Project	<b>IEEE 802.16 Broadband Wireless Access Working Group</b> < <a href="http://ieee802.org/16">http://ieee802.org/16</a> >	
Title	<b>Efficient and Secure Security Framework in PKMv2</b>	
Data Submitted	<b>2005-03-15</b>	
Source(s)	Seokheon Cho, Sungcheol Chang, Chulsik Yoon,  ETRI  Sanjay Bakshi, Yigal Eliaspur,  Intel Corporation  Junhyuk Song, Jicheol Lee  Samsung	Voice: +82-42-860-5524 Fax: +82-42-861-1966 <a href="mailto:chosh@etri.re.kr">chosh@etri.re.kr</a>  sanjay.bakshi@intel.com  junhyuk.song@samsung.com
Re:	IEEE P802.16e/D6	
Abstract	The existing PKMv2 is somewhat unorganized and insecure security framework. This contribution provides a resolution for unorganized and insecure issues in the PKMv2.	
Purpose	Adoption of proposed changes into P802.16e/D6	
Notice	This document has been prepared to assist IEEE 802.16. It is offered as a basis for discussion and is not binding on the contributing individual(s) or organization(s). The material in this document is subject to change in form and content after further study. The contributor(s) reserve(s) the right to add, amend or withdraw material contained herein.

## Efficient and Secure Security Framework in PKMv2

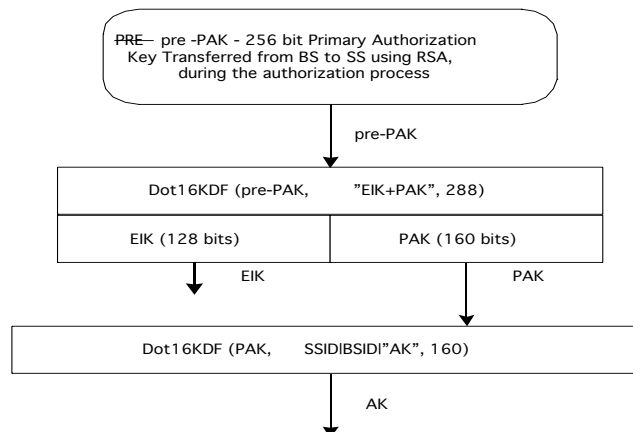
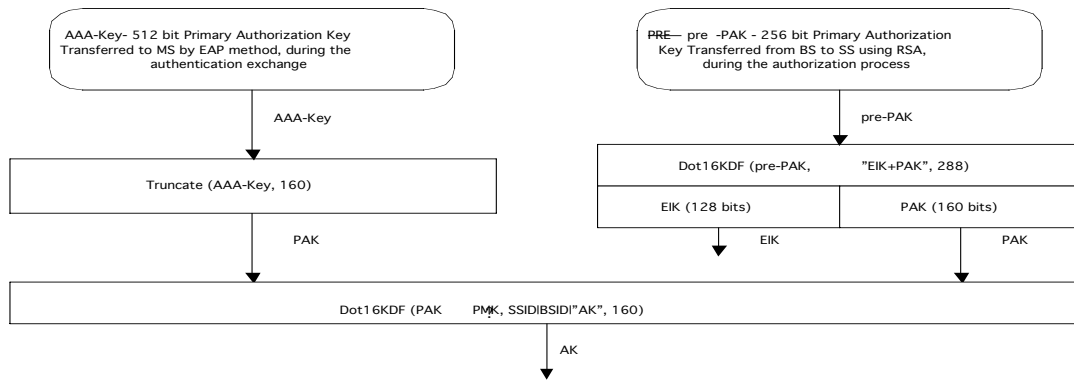
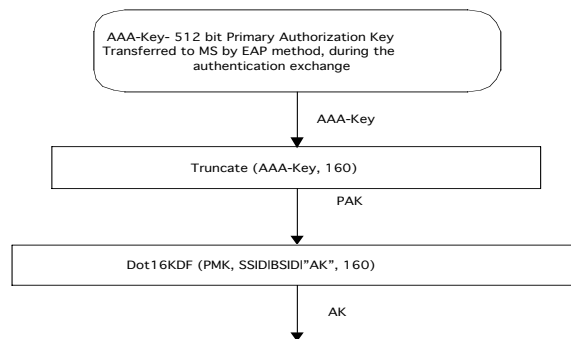
- The AK is derived from PAK or/and PMK which are generated and distributed from the BS and Authenticator, respectively. A Nonce from MS as well as BS is necessary to generate AK so as to make more secure key generation mechanism.
- The input key used for AK generation is the only PMK. The PAK should be also used to generate the AK as not input data but an input key.
- The value of EAP session-id is not changed, even though the new AAA-key is refreshed. That is, even if PMK is updated, the value of PMKID ( $\Rightarrow$  hash64(EAP session-id)) and AKID ( $\Rightarrow$  hash64(EAP sessionid|PAKID|BSID)) is not also changed. Therefore, AKID is unsuitable as the identifier or sequence number needed to distinguish new AK from old AK.

- a) The input key for generating the AK should be both PAK and PMK. The exclusive-or (XOR:  $\oplus$ ) value of PAK and PMK as input key is used to generate the AK. The generation method of the AK is as follows.

$$AK \Leftarrow \text{Dot16KDF}(\text{PAK} \oplus \text{PMK}, \text{SS\_NONCE} | \text{BS\_NONCE} | \text{SSID} | \text{BSID} | \text{"AK"}, 160)$$

$$AK \Leftarrow \text{Dot16KDF}(\text{PAK}, \text{SS\_NONCE} | \text{BS\_NONCE} | \text{SSID} | \text{BSID} | \text{"AK"}, 160)$$

$$AK \Leftarrow \text{Dot16KDF}(\text{PMK}, \text{SS\_NONCE} | \text{BS\_NONCE} | \text{SSID} | \text{BSID} | \text{"AK"}, 160)$$

**Figure 131-AK with the only RSA-based only authorization process**

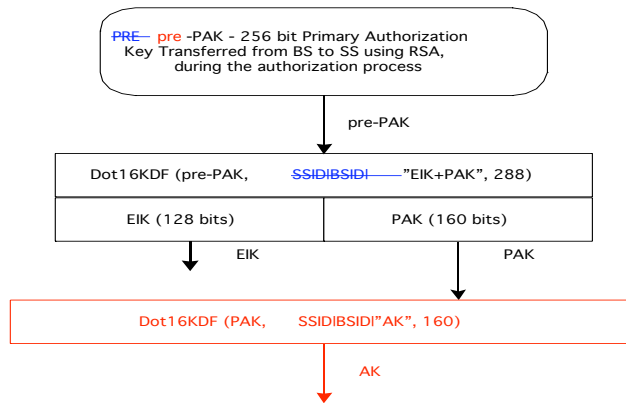
Figure 131 outlines the process to calculate the AK when the RSA-based authorization process has taken place, but where the EAP-based authentication process hasn't taken place, or the EAP method used has not yielded an AAA-key:

If (RSA-based authorization and EAP-based authorization)  
 $AK \leq \text{Dot16KDF}(\text{PAK} \oplus \text{PMK}, \text{SSID}|\text{BSID}|"AK", 160)$   
 Else if (RSA-based authorization)  
 $AK \leq \text{Dot16KDF}(\text{PAK}, \text{SSID}|\text{BSID}|"AK", 160)$   
 Else if (EAP-based authorization)  
 $AK \leq \text{Dot16KDF}(\text{PMK}, \text{SSID}|\text{BSID}|"AK", 160)$

**Figure 132-AK with RSA and EAP authorization process**

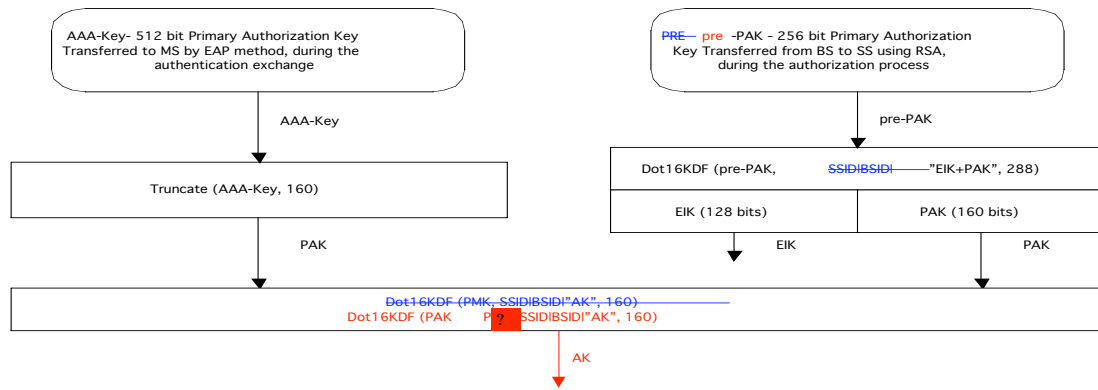
Figure 132 outlines the process to calculate the AK when both the RSA-based authorization exchange has taken place, yielding a PAK and the EAP based authentication exchange has taken place, yielding an AAA-key:
